3.0 Masterplan

3.4 Design Evolution

Design workshops with LBI Officers

Masterplan presented to DRP - July 2021

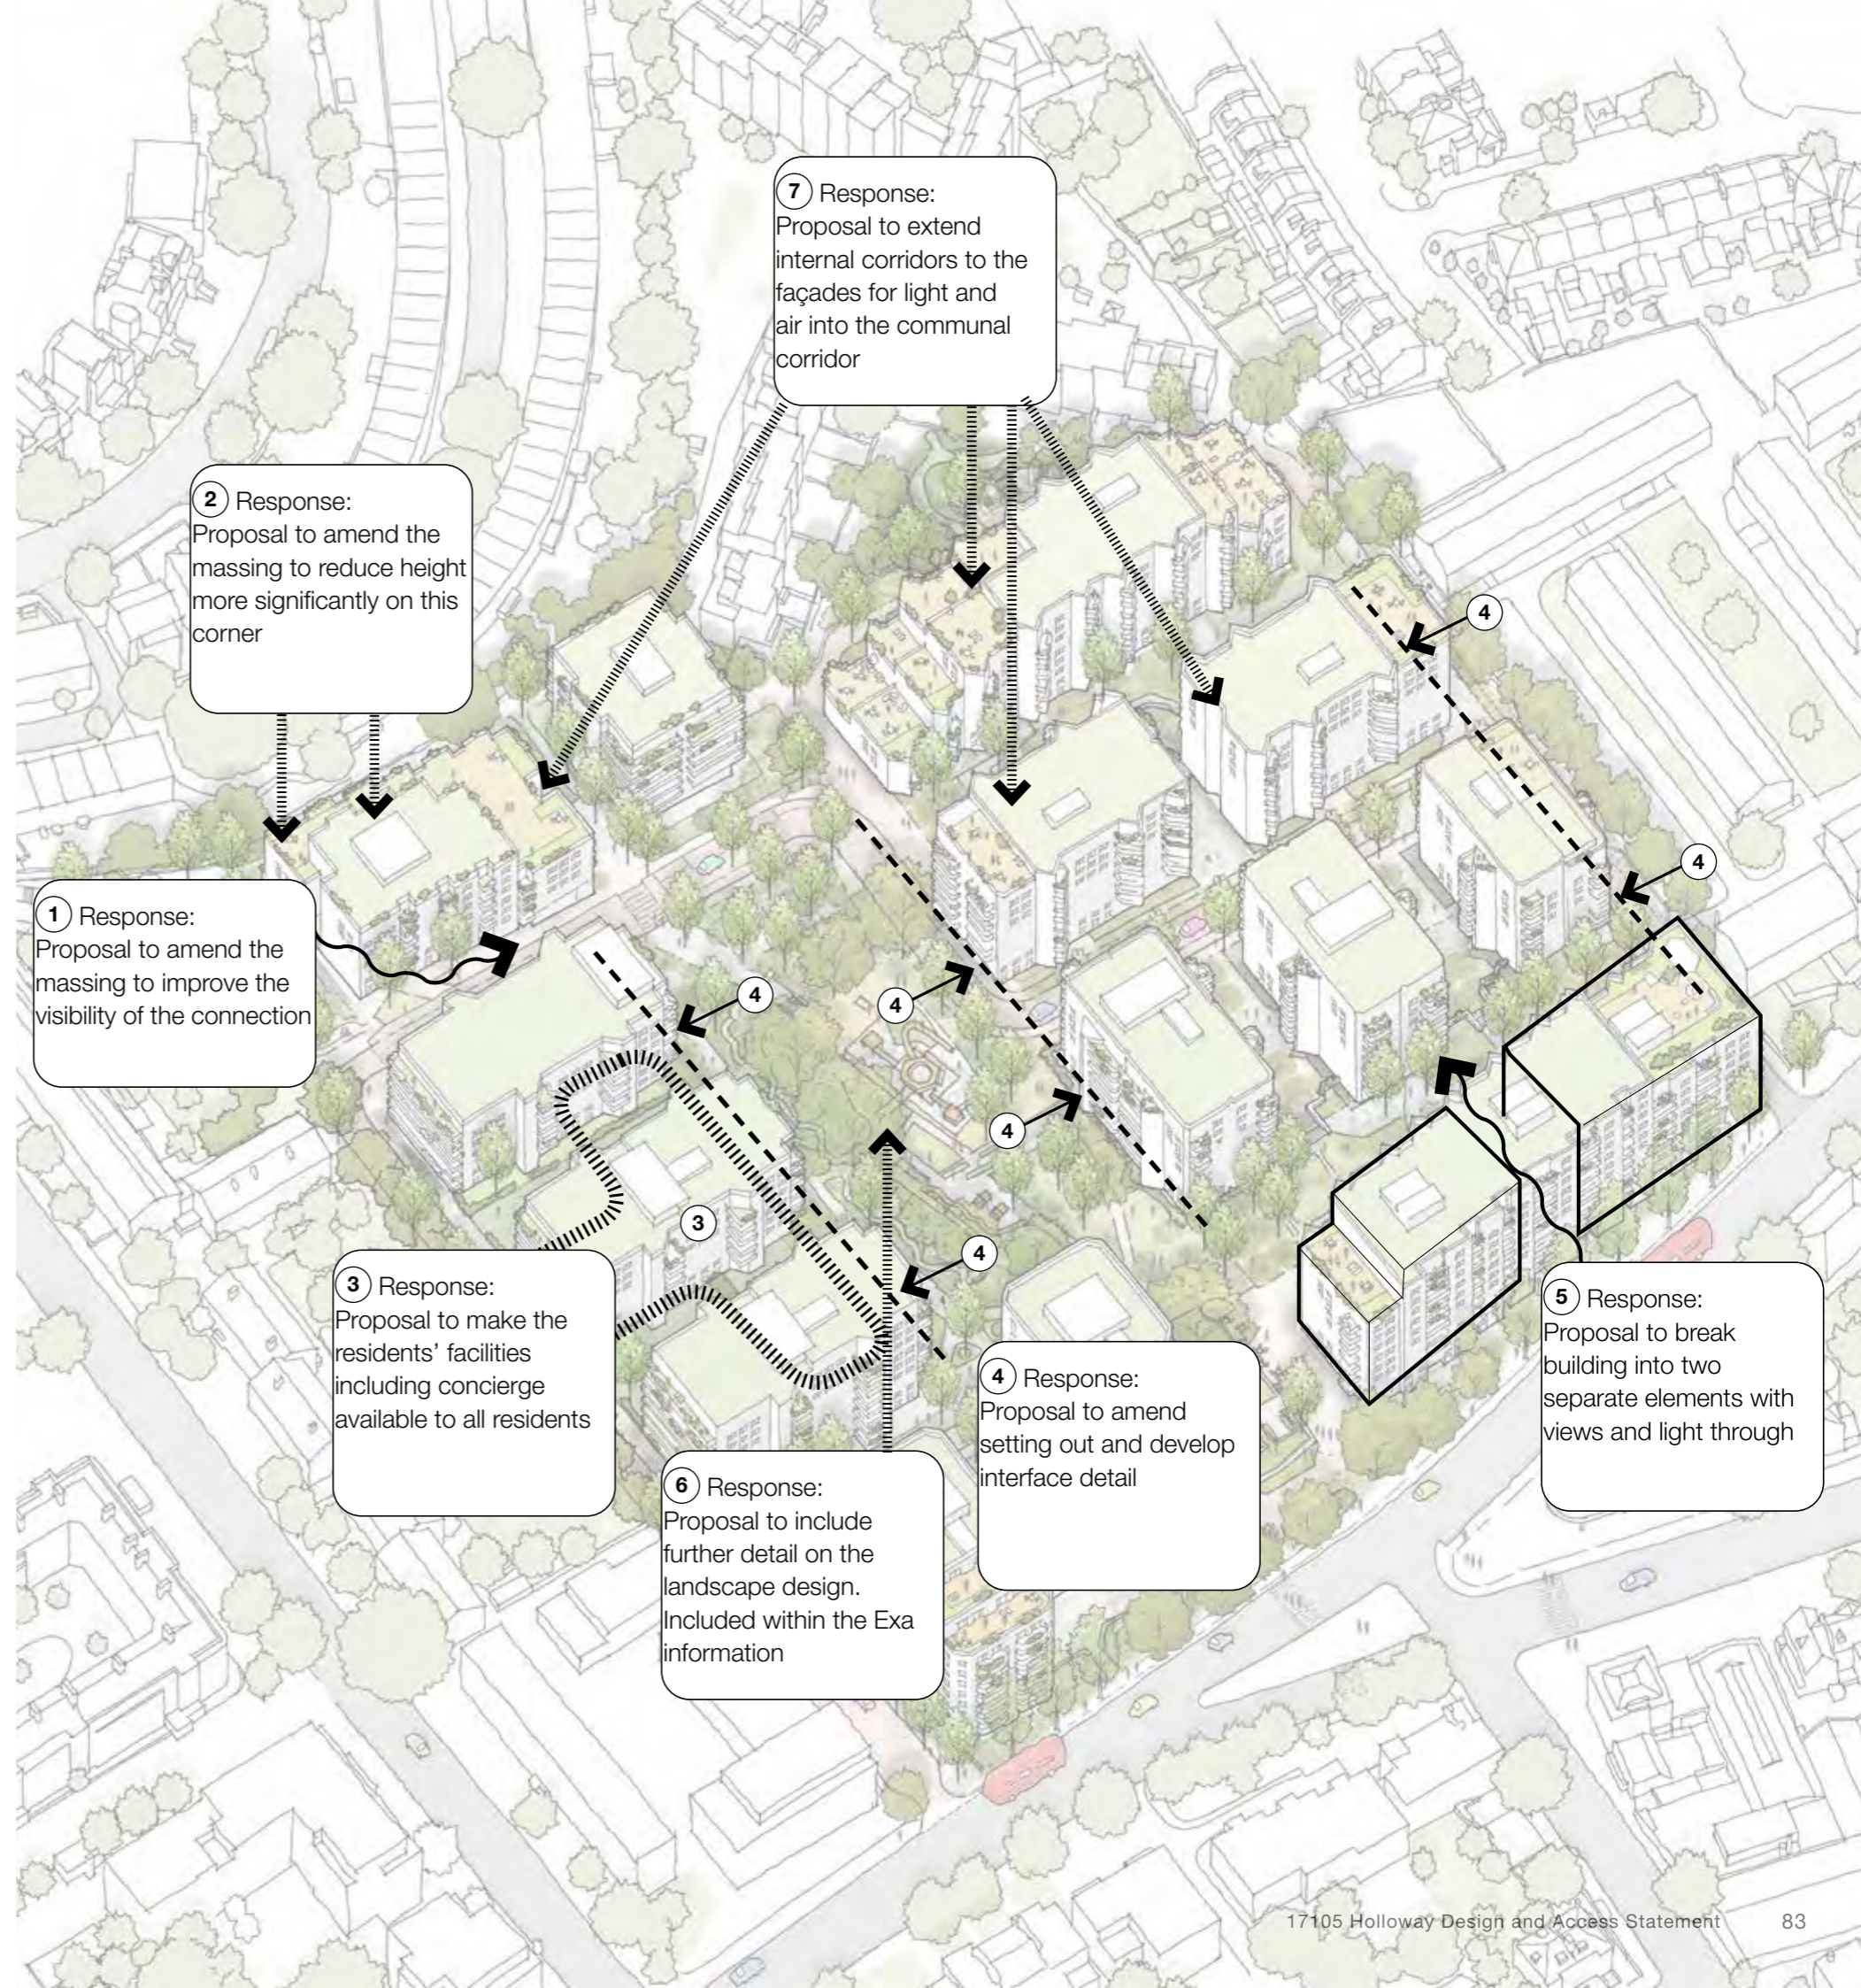
1 Connections

More could still be made of the connections and to consider measures such as ante rooms. More emphasis is needed as to how these connections lead out and into their neighbourhoods. The Panel advised that the connections need to be as well integrated as possible into the overall form of the scheme even those not being brought forward as part of the application.

2 Block E1 more crumbling form

3 Block D concierge available for all

Concern that this only serves market units. Recommend some such facilities be included to other blocks with a mix of tenures. Shared workspace, included in the communal facilities, and potentially elsewhere on the site, would benefit residents and the scheme in general.

4 More detail on ground floor interface

Panel did query how the buildings met the edges of the internal street's pavements and considered some appeared to be uncomfortably tight to pavement edges. Key design consideration is how base of Block D meets and addresses park.

5 Break apart B2

Recommended that the Parkhurst Road frontage elevation in particular be 'broken down' and more strongly articulated in order to mitigate the height, bulk and mass.

7 Glazing + Ventilation

Encouraged to pursue inventive ways of introducing daylight to the common areas, stairwells & corridors, to create attractive and sustainable routes to individual front doors.

Responding to consultation for Plot E

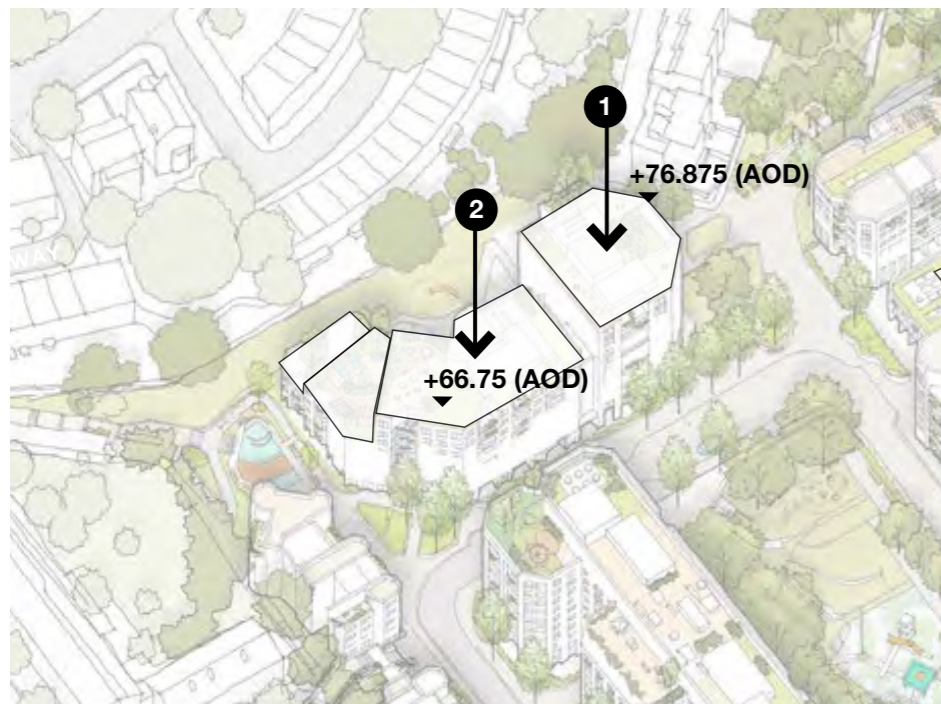
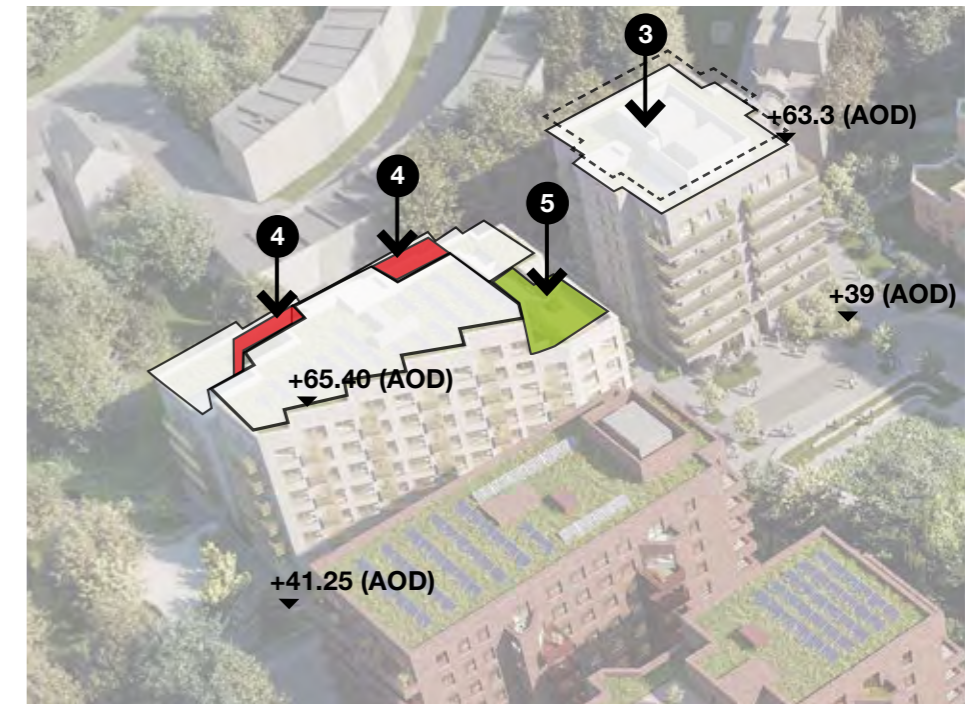
In response to consultation we have reduced the scale and mass of E1 and E2, the following information details the change between consultation events in response to feedback.

1 Scale reduced to the taller element

In response to items raised we have reduced the height of the tallest element. The maximum height reduced by 12.5m. This is a reduction of 4 floors. We now propose a 7 storey building 24m tall and 21.5m from the nearest Penderyn Way property.

2 Scale reduced to the lower element (E1)

In response to items raised we have reduced the height of the lower element. The maximum height reduced by 1.35m. This sits below the key LV4 A & B views from Archway as detailed in the Townscape Assessment.

3 Scale reduced to E2

In response to items raised in the July consultation we have reduced the height of E2. The maximum height reduced by 0.95m.

4 Reduction in mass

In response to items raised in the July consultation we have reduced the mass at the top of E1 and pushing back the ridge line from view of the Penderyn Way properties and improving overshadowing.

5 Setting back roof terrace

In response to items raised in the July consultation we have changed the size and position of the roof terrace to reduced the terrace facing the Penderyn Way pulling it away from the edge to prevent overlooking.

Key changes in response to comments

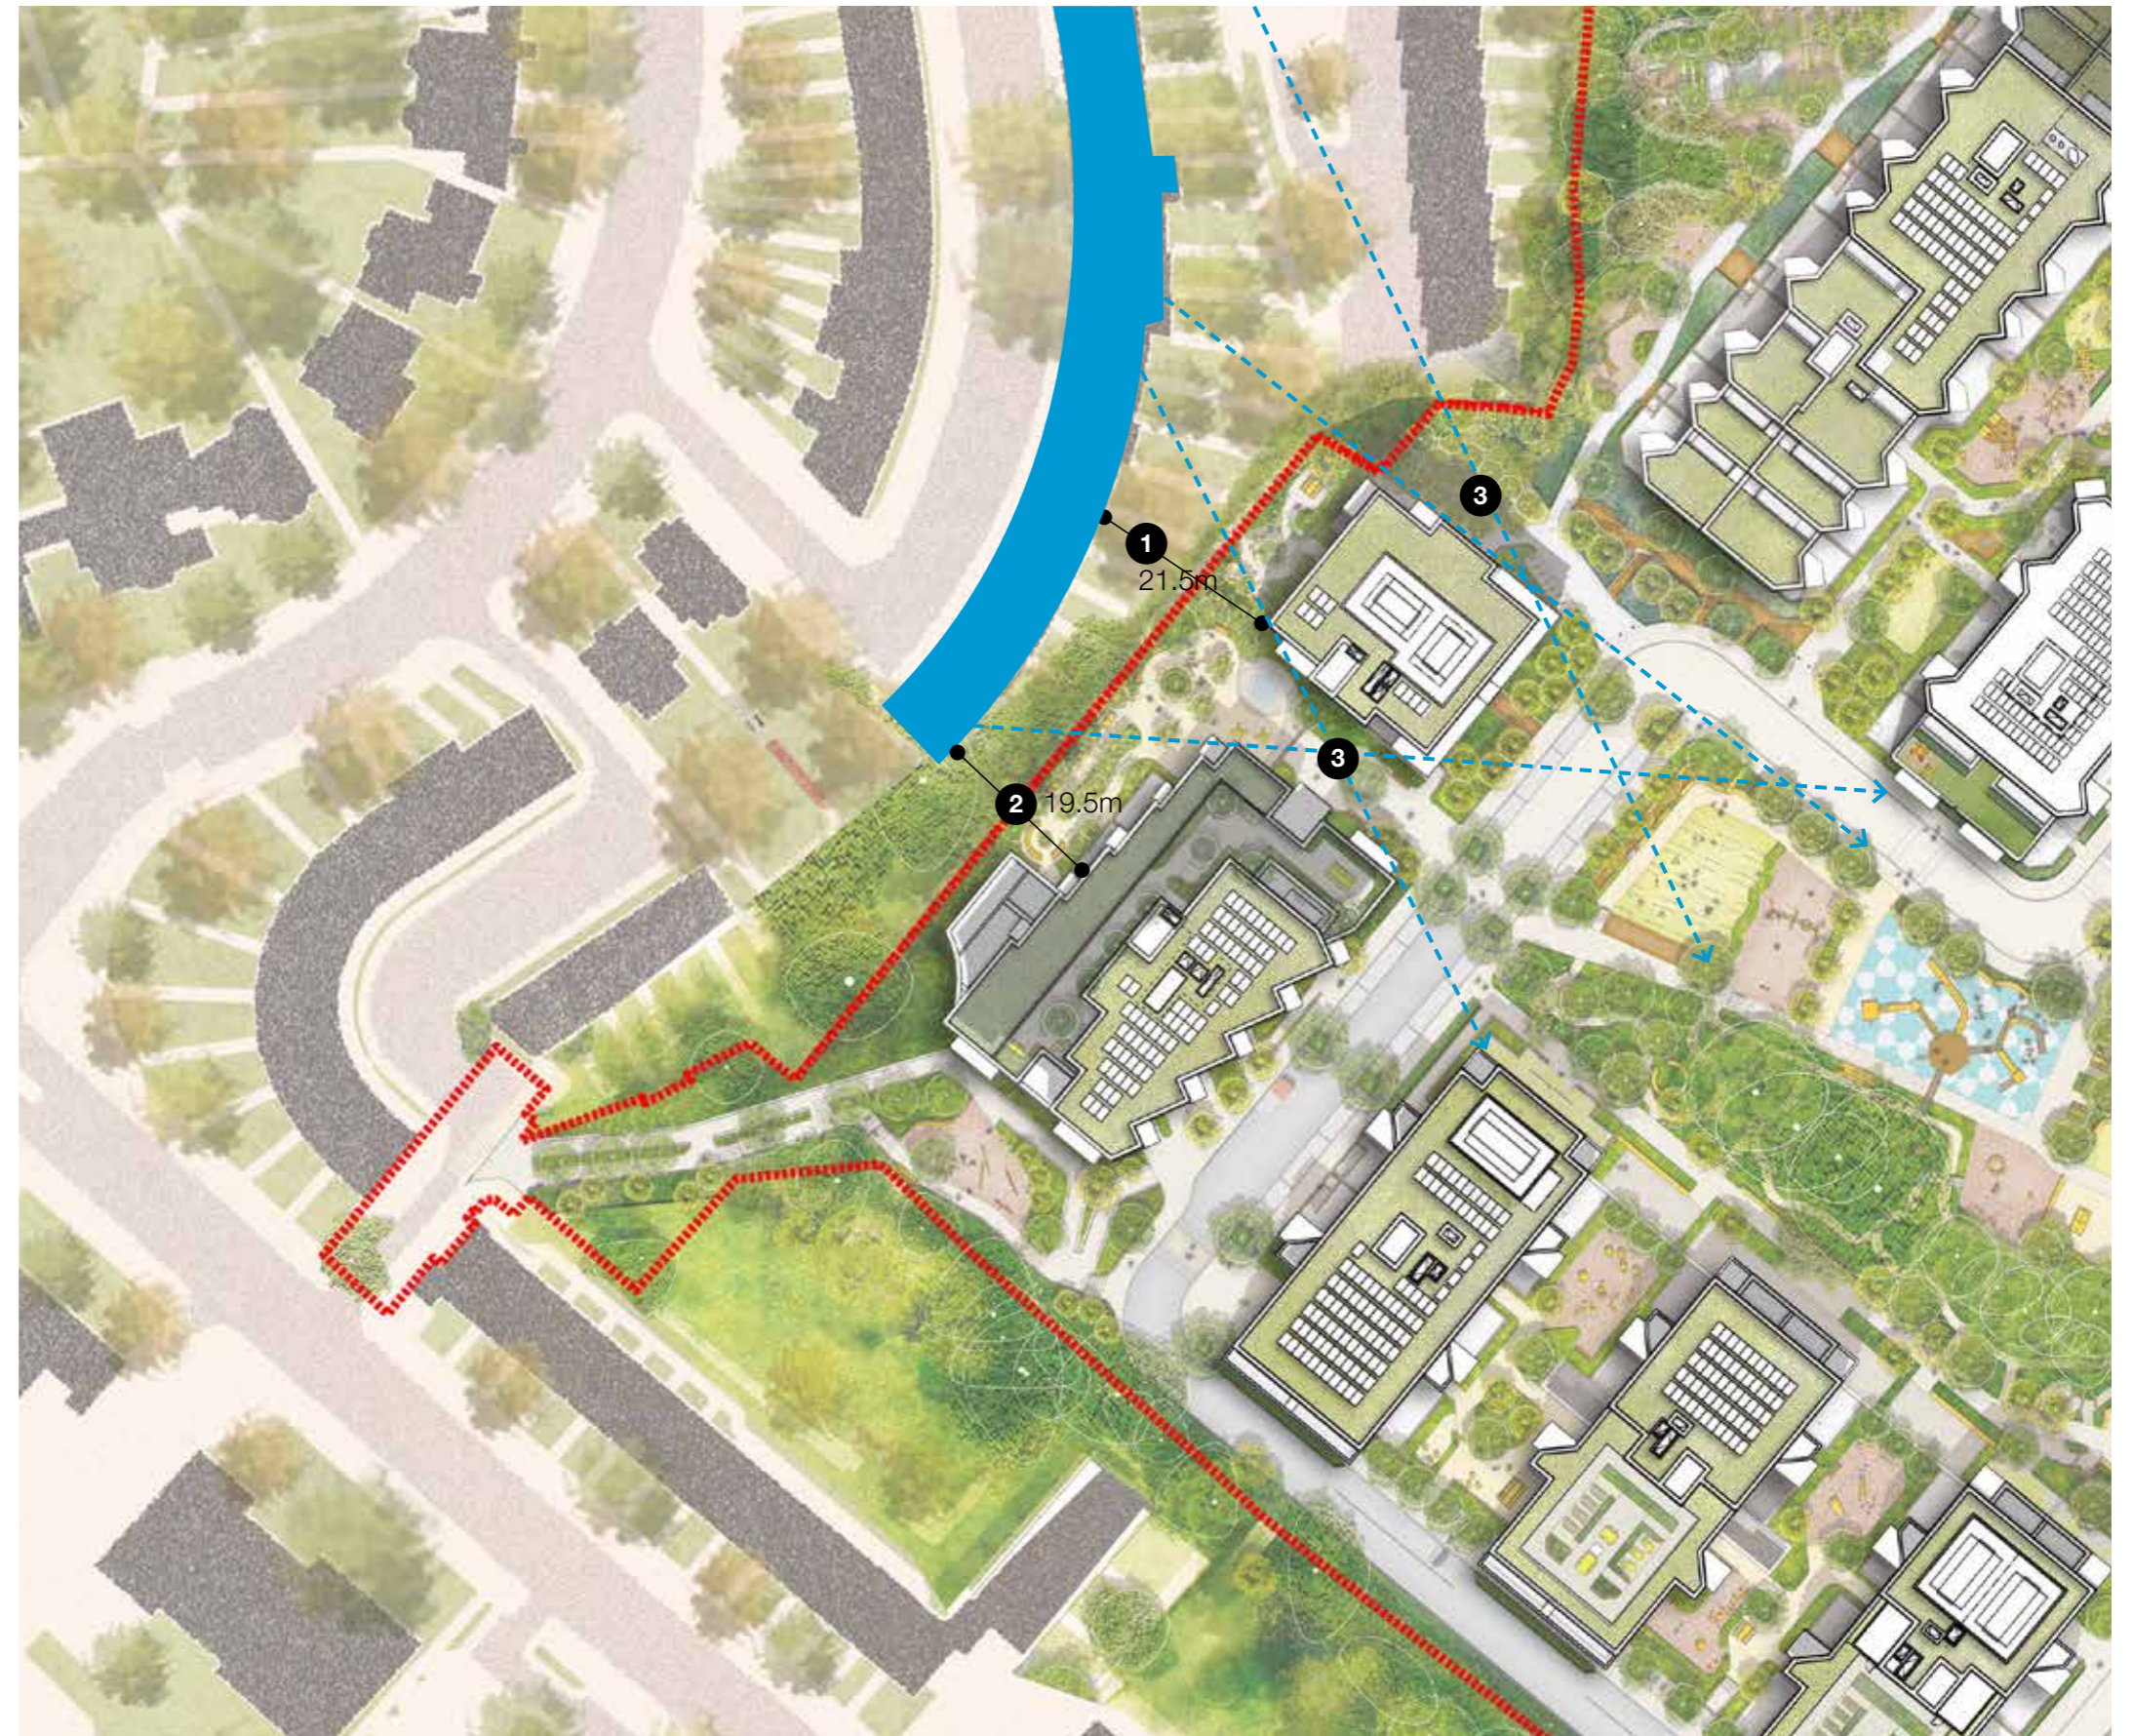
The following details the plan changes in response to consultations.

- ① Revised proposals are pushed back 3.5m from nearest neighbours to 21.5m.
- ② Revised proposals are pushed back 1.5m from nearest neighbours to 19.5m.
- ③ As a result of opening up the gap between E1 and E2 the Penderyn way properties highlighted in blue have a potential view into the central park. In the existing condition this view is also not available as it is blocked by the prison and prison walls.
